SI20.00-P-0001A	Service information on coolant	28.9.99
-----------------	--------------------------------	---------

MODELS 124, 126, 129, 140, 163, 168, 170, 201, 202, 208, 210, 220, 461, 463

28.9.99	Replaces SI 20/50 of 08.03.94	Please remove SI 20/50 from your file.
---------	-------------------------------	--

P20.30-0202-01

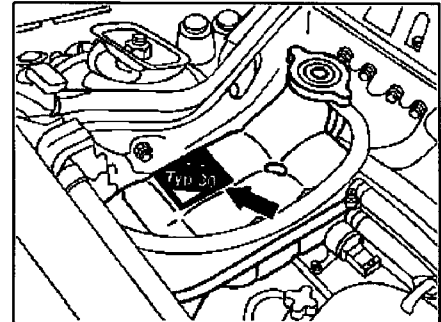
A special corrosion protection/antifreeze agent (KFM) type 30 is available for "aluminum corrosion in cooling circuit".

- 50 Vol. % water
- 50 Vol. % corrosion/antifreeze agent provides frost protection up to -37°C

👉 Fit warning sticker clearly visible on the expansion tank (see arrow)

ⓘ KFM type 30 must not be mixed with any other antifreeze agents
